BEFORE THE OREGON PUBLIC UTILITIES COMMISSION

2017 Integrated Resource Plan

Docket LC 68

**SIERRA CLUB COMMENTS
[REDACTED]**

Figure 16. Coal deliveries to Jim Bridger plant

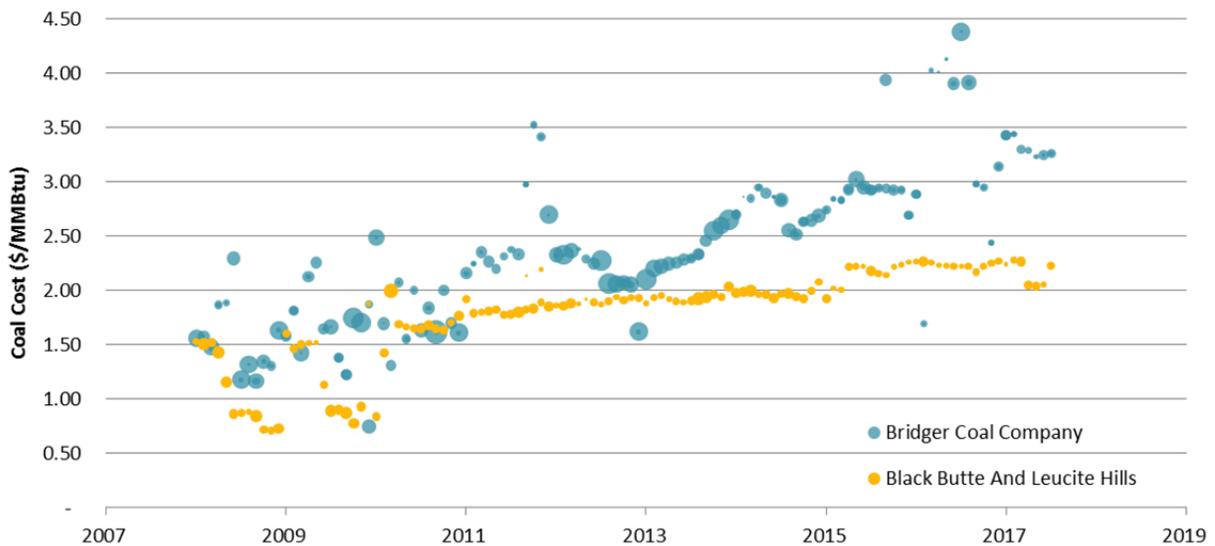
Inexplicably, IPC did not include the uncertainty of coal prices in its stochastic analysis. Jim Bridger is supplied by Black Butte and Bridger Mine. Historically, Black Butte has served approximately one-third of Bridger’s requirements, while Bridger Mine has served the remainder from an older surface mine and a newer underground mine. Bridger Mine is owned by Bridger Coal Company, a wholly owned subsidiary of a PacifiCorp and IPC partnership. Despite being a mine-mouth facility with regulated utility ownership, the cost of coal from Bridger Mine has been anything but predictable over the last decade, as shown in Figure 16, below.⁷² Coal quality problems at the underground mine have led to a continuous re-allocation and long-term planning process. Recently, PacifiCorp reported that an expensive longwall miner had been extensively damaged during operations,⁷³ causing another delay in mining activities. Overall, the cost of coal procured for Bridger plant has varied substantially over time.

IPC should have included coal prices in its stochastic analysis. The correct way to model the coal price stochasticity is very similar to the correct way to model gas price stochasticity—with a log-normal or similar distribution wherein the median of the distribution aligns with the forecasted coal price trajectory. The variability of the price should reflect all of the risks associated with the mine detailed above.
